Sacramento Municipal Utility District Folsom Administrative Operations Building Project

Final Initial Study and Mitigated Negative Declaration •

February 2025

Figure A-3
Sightline cross-section illustration for viewpoint from bike/ped trail inline with KOP 3 sightline.

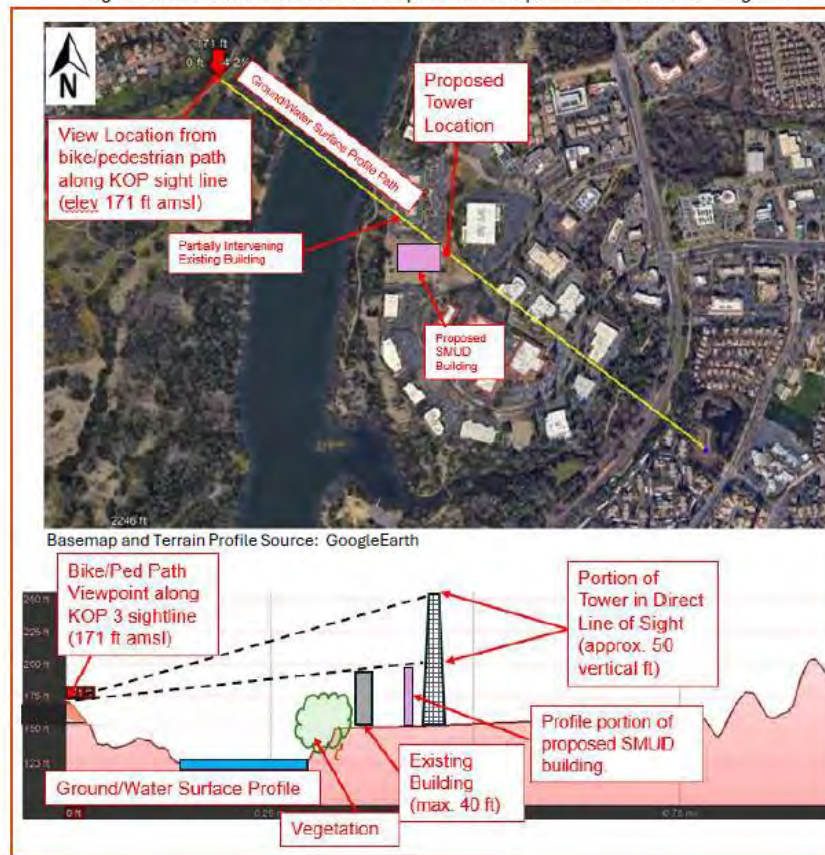
As shown on IS/MND Figure 3.1-1, KOP 3 is located adjacent to a residential development to the northwest of the Project site. Though not identified in the IS/MND, KOP 3 is approximately 2,400 feet from the Project site. The IS/MND conclusion that the Project would blend with the surrounding development is flawed. Although the visual simulation downplays the visibility of the tower (a zoom into the simulated view shows the tower merely as a few grey pixels), at a distance of 2,400 feet, the Project's tower would be readily apparent in the view and would present a new, unnatural/cultural component to the viewshed. The human eye can easily and clearly see a 100-foot tower from a distance of 2,400 feet, regardless of whether that same clarity is presented in a photographic simulation.

Figure A-4 viewpoint is a lower elevation than KOP 3 and along a bike trail that has much higher use than the KOP 3 viewpoint. Figure A-4 includes a 100-foot-tall three-dimensional block illustration situation at the proposed tower location. The 3D block is "clamped to the ground" to accurately demonstrate the height of the tower as seen from the Figure A-4 viewpoint along the bike trail. As shown, in Figures A-3 and A-4, the tower would extend above the view horizon, as opposed to blending with adjacent development in the technology center as represented in the KOP 3 simulation of the IS/MND.

Figure A-6
Sightline cross-section illustration for viewpoint from Lake Natoma surface west of Project site.

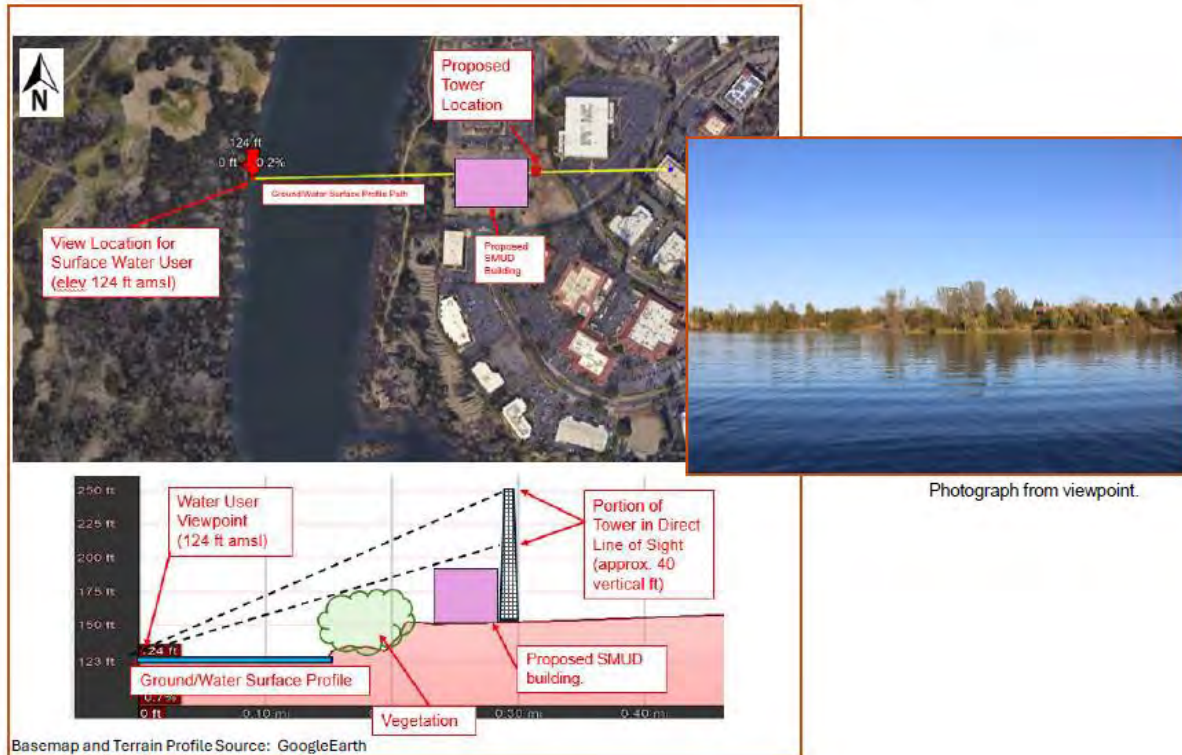
unique visual character and outstanding visual quality. Figure A-1 in Attachment A of this letter illustrates the estimated approximately 160 acres of Lake Natoma surface from which the tower would be partially visible. Figure A-6 illustrates a sightline cross-section profile from a representative location on the lake surface west of the Project site. SMUD's IS/MND must recognize the viewer sensitive and Project impacts from the vast and important viewing area that the Lake Natoma water surface provides.

The comment also asserts that the analysis is insufficient as it does not discuss the Lake Overlook view. This concern is addressed in Response to Comment 4-2 as well as by the additional renderings provided in Appendix B, Figures 1a, 1b, and 1c, which provides views toward the Project site from the Lake Overlook. As demonstrated in the visual simulations for the Lake Overlook, visibility of the proposed Project would be limited and would be in between existing visible structures to the north and south of the Project site. The proposed monopine tower, as visible from the Lake Overlook vantage point, would be set against a background of more distant trees and would not extend above the background provided by the more distant trees. The monopine design allows for the selection of structural foliage that would have a color similar to surrounding trees. Thus, as viewed from the Lake Overlook, the proposed monopine tower would be difficult to distinguish from other more distant trees and would not have a substantial impact on existing views from that location. The comment does not identify any new significant impacts requiring revisions to the Draft IS/MND. No further action is required.

Figure A-1

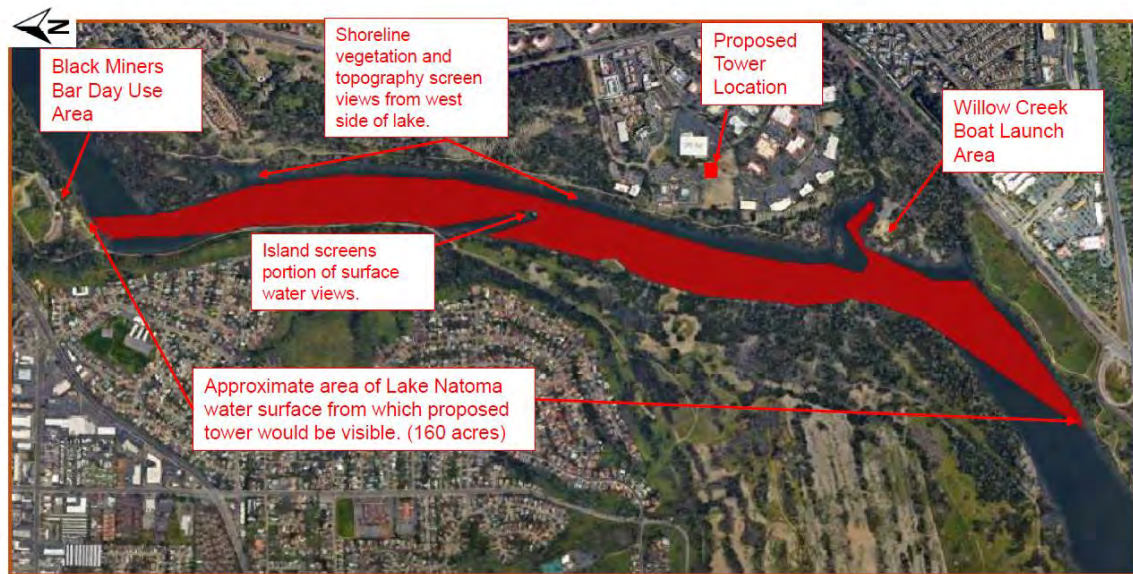
Attachment A to this letter provides a selection of exhibits prepared to support and demonstrate argument herein. Figure A-1 illustrates the approximately 160-acre surface area portion of Lake Natoma from which we estimate there would be a direct view of the upper portion of the proposed tower. Figure A-2 provides a location index and explanation of sightline profile cross-sections prepared to demonstrate the portion of the tower anticipated to be visible within the line of sight from various view locations around and on Lake Natoma.

Figure 4
Conceptual Site Design

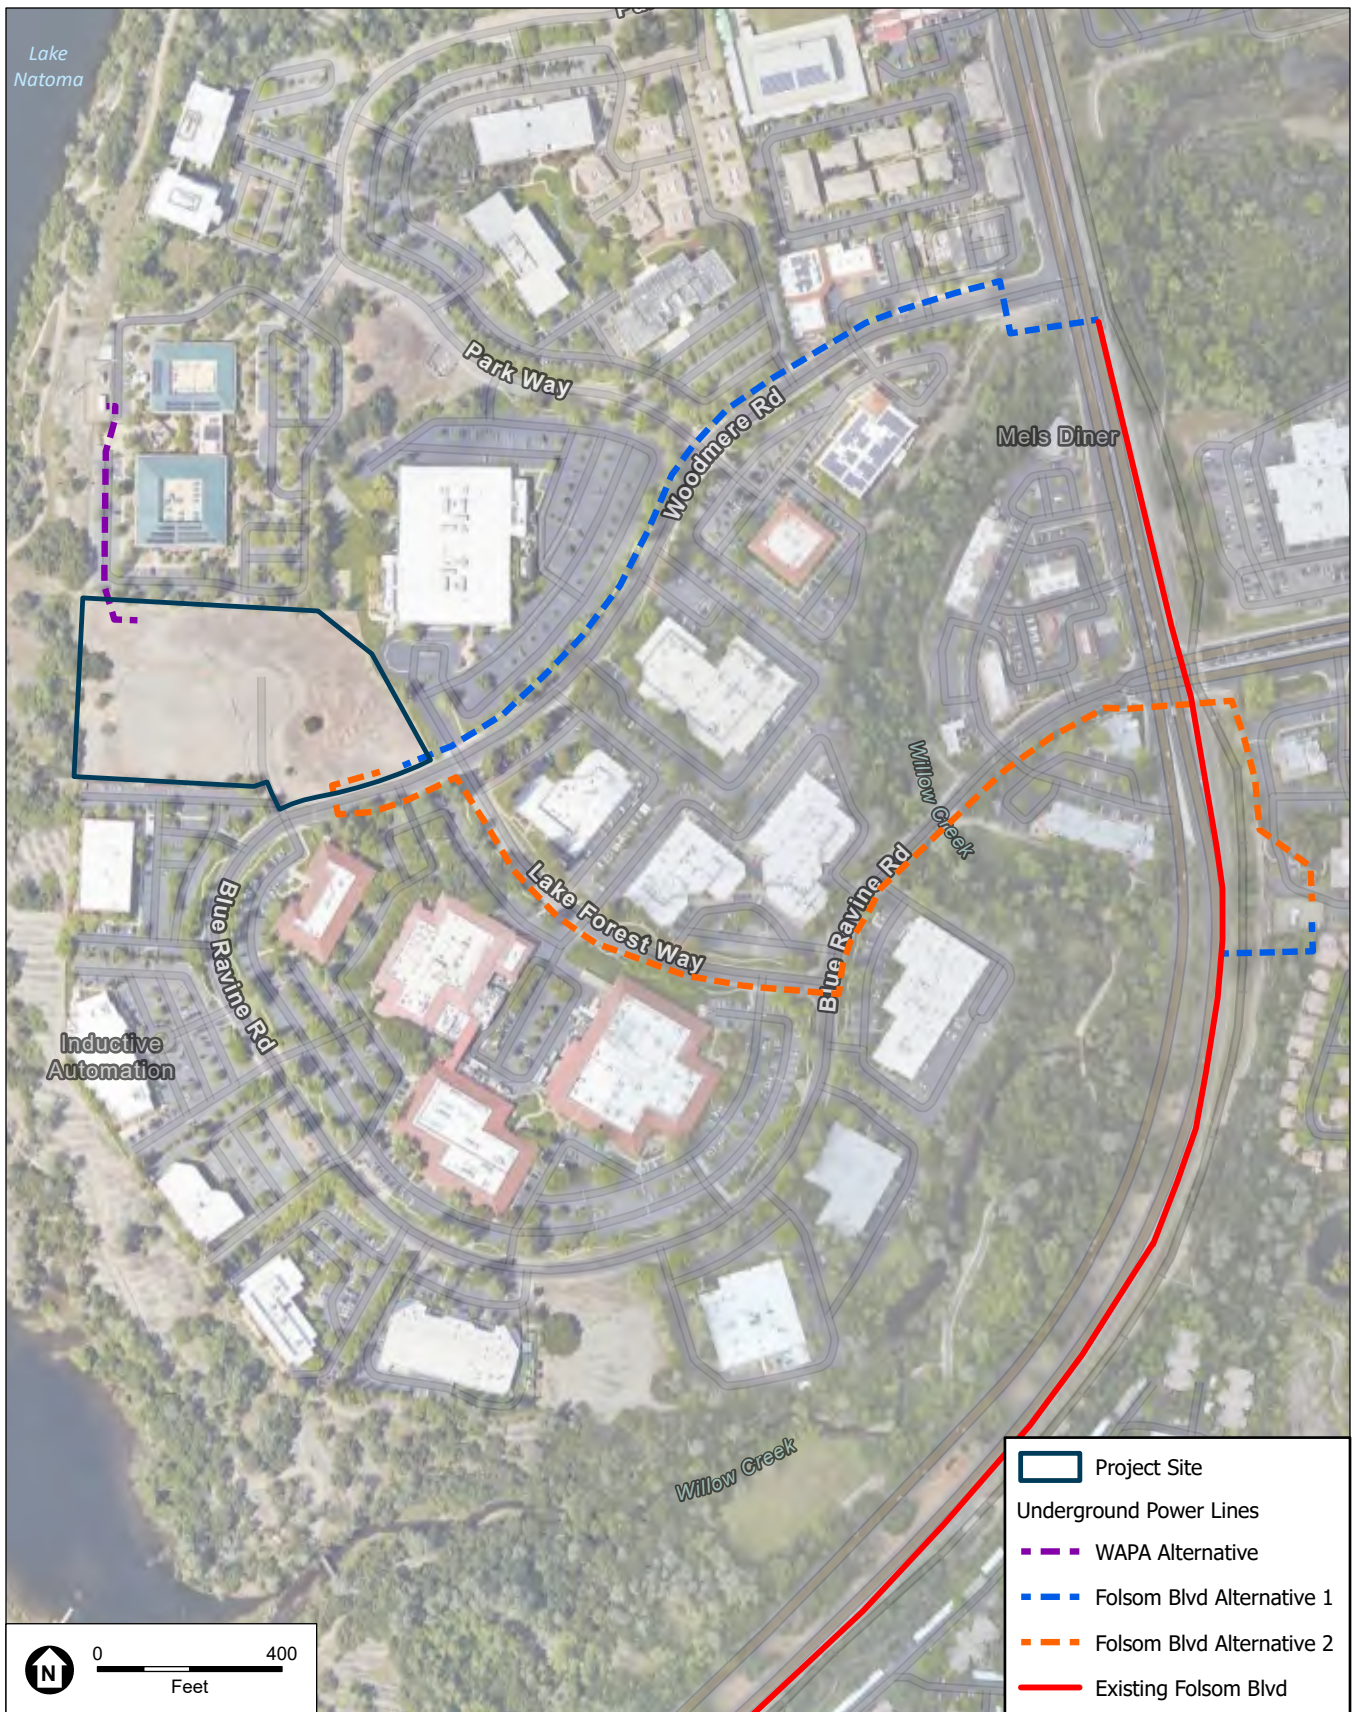
IS/MND includes a Figure 4, "Conceptual Site Design," that shows the proposed (or at least conceptual) location of the tower.

The Project description of SMUD's IS/MND provides the following in describing SMUD's proposed communications tower, "[t]he Project would include a communications tower approximately 100 feet in height, located at the northeast corner of the Project site" (Draft IS/MND, pg. 10) and the IS/MND includes a Figure 4, "Conceptual Site Design," that shows the proposed (or at least conceptual) location of the tower.

Figure 3.1-2. Key Observation Point 1

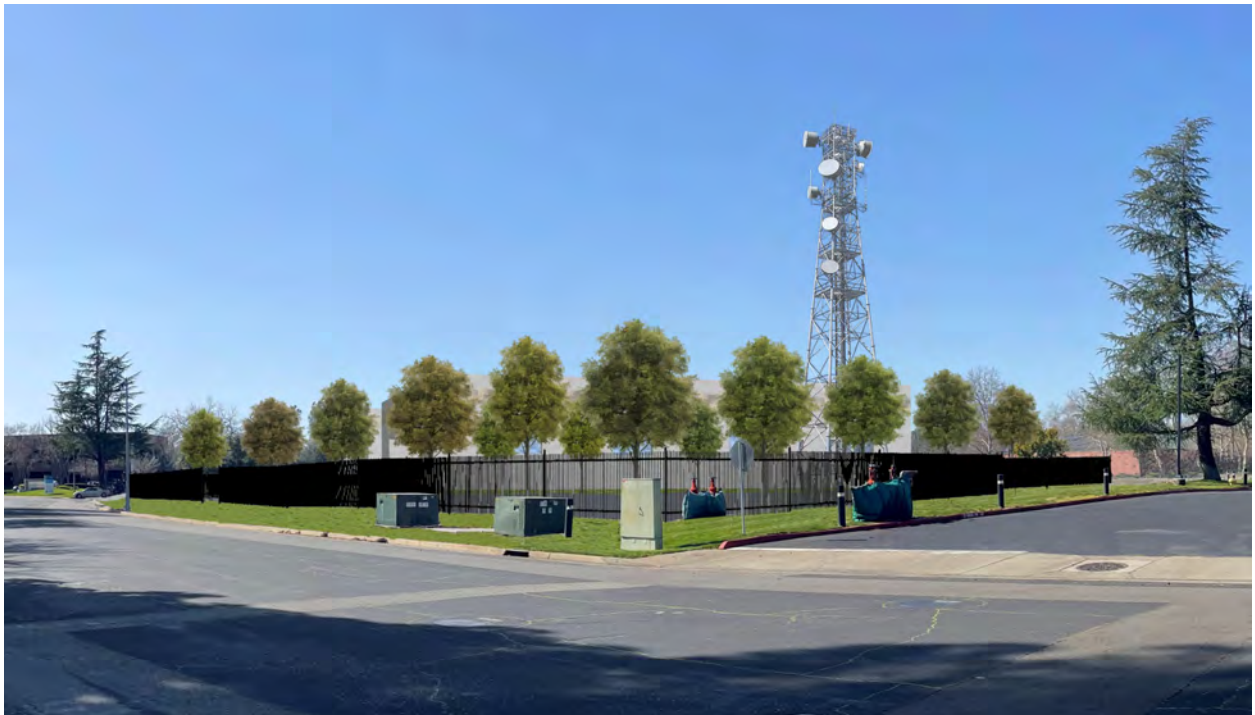
Although one of SMUD's three photo simulations in the IS/MND (Figure 3.1-2, Key Observation Point 1 [KOP 1]) represent what appears to be a free-standing, steel lattice tower, the IS/MND does not describe that this is the actual tower design that is proposed and does not provide other detail about the design. Additionally, the KOP 1 simulation includes an antenna that appears to extend approximately 10 feet above the top of the steel lattice tower. However, the IS/MND provides no discussion of whether SMUD proposes that the top of such antenna would be limited to a maximum height of 100 feet or if SMUD intends that antennae would be allowed to extend even farther above the height of the 100-foot tower. Without a sufficient description of the proposed tower, it is impossible to fully understand and evaluate the visual impacts of the tower. SMUD's IS/MND must be revised to provide sufficient detail for a meaningful evaluation of the proposed tower.

Although one of SMUD's three photosimulations in the IS/MND (Figure 3.1-2, Key Observation Point 1 [KOP 1]) represent what appears to be a free-standing, steel lattice tower, the IS/MND does not describe that this is the actual tower design that
